Fifth Five-Year Review Report

Hunters Point Naval Shipyard San Francisco, California

July 2024

Figure 3-5 March and September 2022 Exceedances of Remediation Goals in Parcels B-1, B-2, and IR 07/18

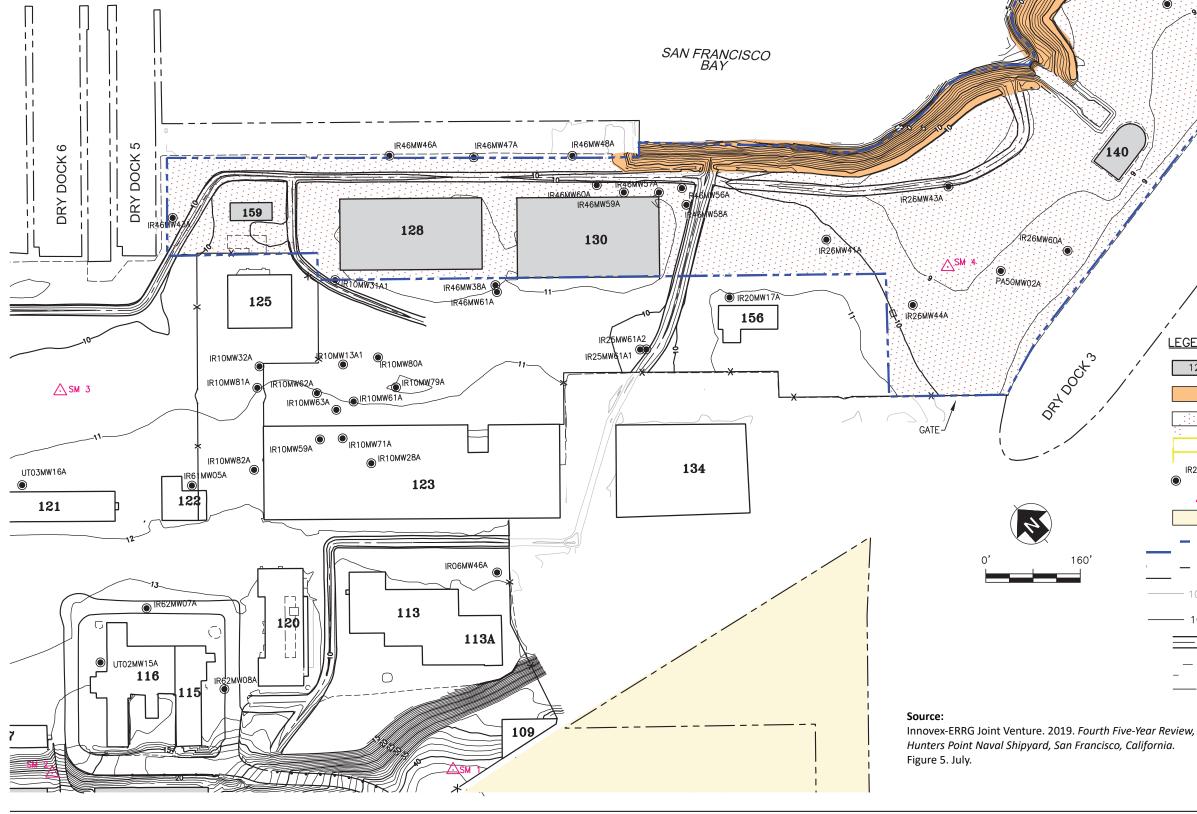
Specific Comment 7: The Draft-Final Five-Year Review should provide a discussion of groundwater flow directions and include groundwater flow path depictions on Figure 3-5, and trend analysis for lead concentrations in wells IR07MW24A and IR07MW26A. With the fluctuating lead concentrations in groundwater and the lack of sentinel wells between the elevated concentrations in groundwater and the Bay, it is unclear if the remedy is adequately protective of ecological receptors and that lead is not being discharged to the Bay.

11. Figure 3-5, March and September 2022 Exceedances of Remediation Goals in Parcels B-1 and B-2 and IR-07/18 and Figures 4-4 through 4-7 - The figures show exceedances of remediation goals in groundwater.

Figure 1: Meta Fix Injection and Rejection Locations (Source: Figure 6 Draft RACSR)

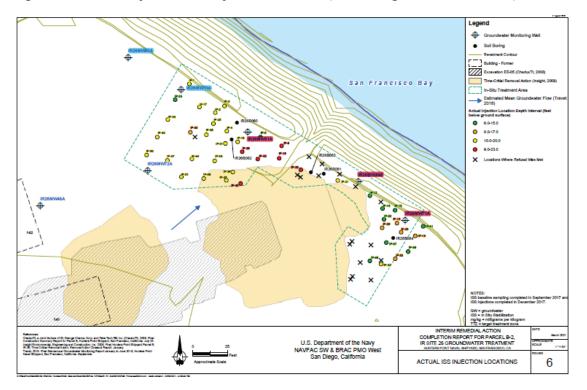
ISS treatment consisted of injecting Meta Fix compound into groundwater at select locations to "immobilize" mercury. Injections occurred in December 2017 at 43 of the planned 52 locations, with refusal reportedly preventing injection at 9 locations (see Figure 1, below). No alternative actions were proposed or taken to address areas where Meta Fix was not injected.

Figure 3: Time Series Plot of BGMP Data for 5 "Sentinel" Wells (Source: Figure A-4, Summary of July through December 2020 Semiannual Groundwater Monitoring Data and Exceedances in Groundwater, March 19, 2021)

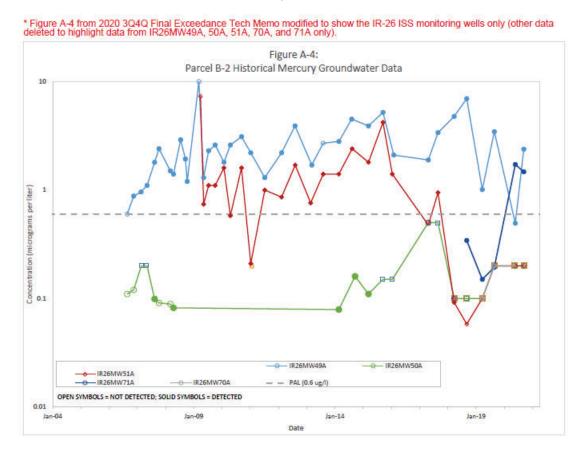
1, below) and time series plot (see Figure 3, below). Please note that the Figure 3 time series plot that the Navy provided (Source: *Summary of July through December 2020 Semiannual Groundwater Monitoring Data and Exceedances in Groundwater, March 19, 2021*) only includes data collected via the Basewide Groundwater Monitoring Program (BGMP) and not the data from the 4 quarters of performance monitoring. To facilitate viewing, we modified the original time series plot to only show the 5 "sentinel" wells.

Figure 2: "Sentinel" Wells (Source: Figure 4 Draft RACSR); IR26MW49A, IR26MW51A, and IR26MW71A in red

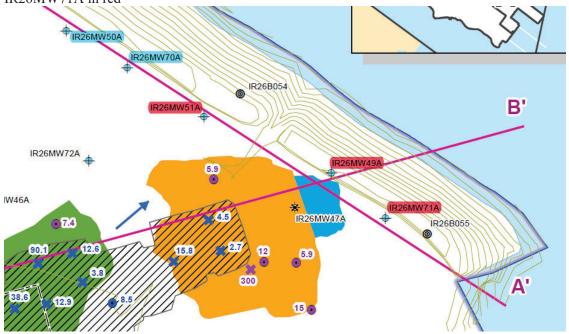
In sum, the ISS treatment has failed as a treatment technology to achieve the desired results. See Figure 2, Table 1, and Figure 3 presented again, below, for convenience.
